INITIAL FIRE SAFETY INSPECTION REPORT

Square Fashions Limited (New Extension)

RSC ID: 25581

Date: 21 March 2024

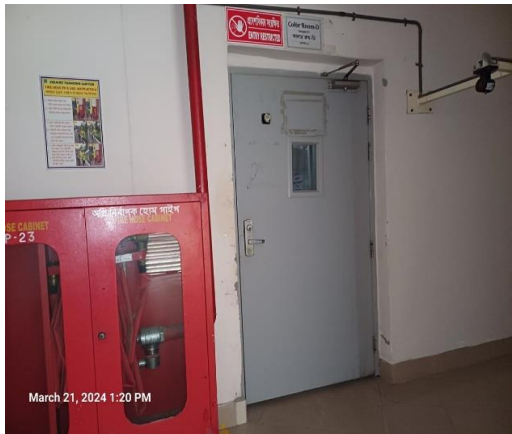
SI No.	Category	Findings	Required Action	Remediation Time Frame
F-1	Fire Rated Construction	The exit stairs are not separated from [work areas, other spaces] on each floor by fire-rated construction. Location: B-3, B-8, B-14, B-9, B-11, B-12, B-19.	Provide minimum 2-hr fire rated construction for buildings 4 storied or more and 1-hr for upto 3 storied. Seal all unprotected openings to separate the exit stairs from work areas and other spaces on all floor levels by 90 minutes for 2 hr construction and 60 minutes for 1-hr construction. Ensure that the fire rated doors are self-closing and positive latching and that they are provided with fire exit (panic) hardware where serving production floors and provide vestibules to avoid direct discharge from storage to exit stair enclosure. If fire rated doors are required to be held open for functional reasons, provide automatic closing devices tied to the fire alarm system. Once fire doors are installed, every door in a stair enclosure serving more than 5 stories shall be provided with re-entry unless it meets RSC Technical Guidelines (Standard) 6.8.3.1If fire doors are required to be held open for functional reasons, provide automatic-closing devices tied to the fire alarm system. Exit enclosures shall be protected with a construction of at least 4 hr fire separation as per 2.13.6 of BNBC 2006 Part 3 Ch 4 for J occupancy.	Within 3 Months

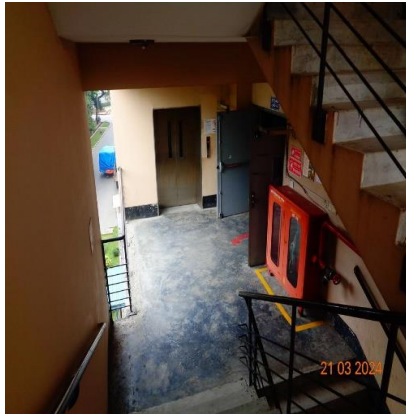
F-7	Fire Rated Construction	Elevator shafts are directly open into the inside of Exit Stair. Location: B-8, B-9 & B-3	An exit stairway shall not be built around a lift shaft unless both of them are located in a smoke proof enclosure and made of a material with fire resistance rating required for the type of construction of smoke proof enclosure. So, ensure the lift shaft is 2-hr fire rated including opening protection with similar rating.	Within 3 Months
-----	-------------------------	--	--	-----------------

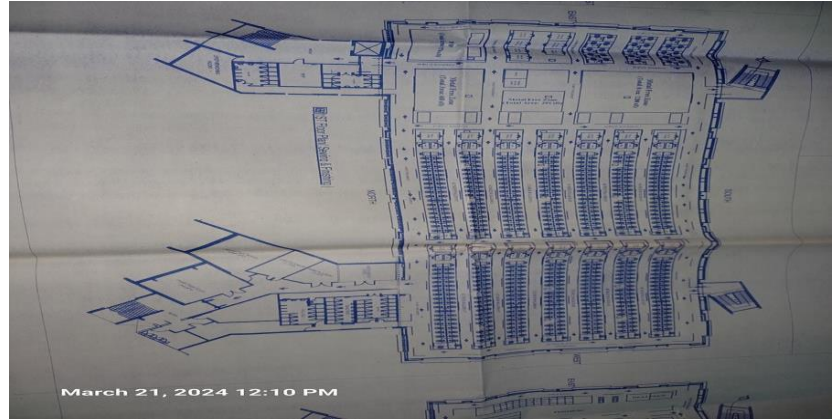
F-10	Fire Rated Construction	The Building-8 is interim constructed where structural members are constructed by steel and have been found in exposed condition without any fire protection.	The Building-8 shall be type-1 or type-2 construction in accordance with the RSC Technical Guidelines (Standard) 3.5.2.1 and BNBC Part-2, Table-3.2.4. Construction type shall be Type-1 for J occupancy. Provide required fire rating on the structural elements by following Section 4.4 and Table 4.4.1 of the RSC Technical Guidelines (Standard) or Table 3.3.1 and Table 4.1.1 from BNBC Part 4. Consult a qualified fire protection engineer to design the rated construction barriers in between two floors and in structural members.	Within 6 Months
------	-------------------------	--	---	-----------------

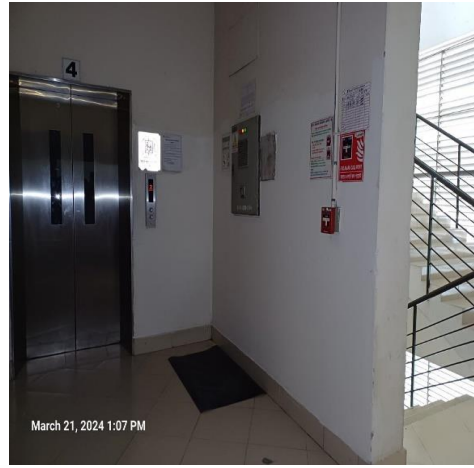
F-12	Fire-Rated Construction	Electrical Panel box was located in the exit stair-4. Location: Ground Floor of B-8, B-12	Remove all electrical panel box from exit stairs.	Within 1 Month
------	-------------------------	--	---	----------------

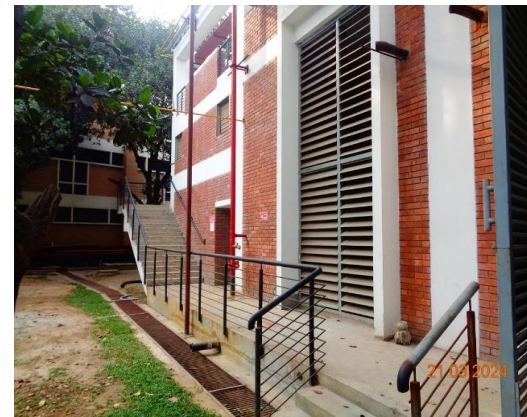
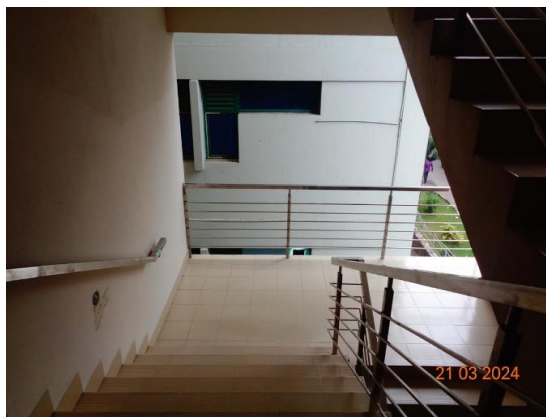
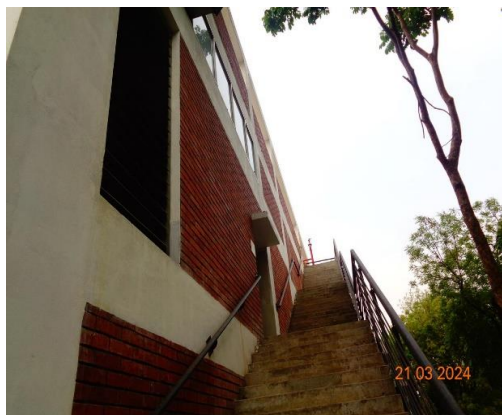
F-16	Fire Rated Construction	The exterior exit stair is not separated from the building. Location: B-14 & B-19	Exterior exit stairs shall be separated by minimum 2-hr fire-rated construction and The rating of the exterior wall shall extend 3.05 m (10 ft.) beyond the ends of the stair structure. Provide minimum 2-hr fire rated doors to separate the exit stairs from work areas and other building spaces on all floor levels. Ensure that the fire doors are self-closing, positive latching and that they are provided with fire exit (panic) hardware where serving production floors. If fire doors are required to be held open for functional reasons, provide automatic-closing devices tied to the fire alarm system.	Within 3 Months
------	-------------------------	--	--	-----------------
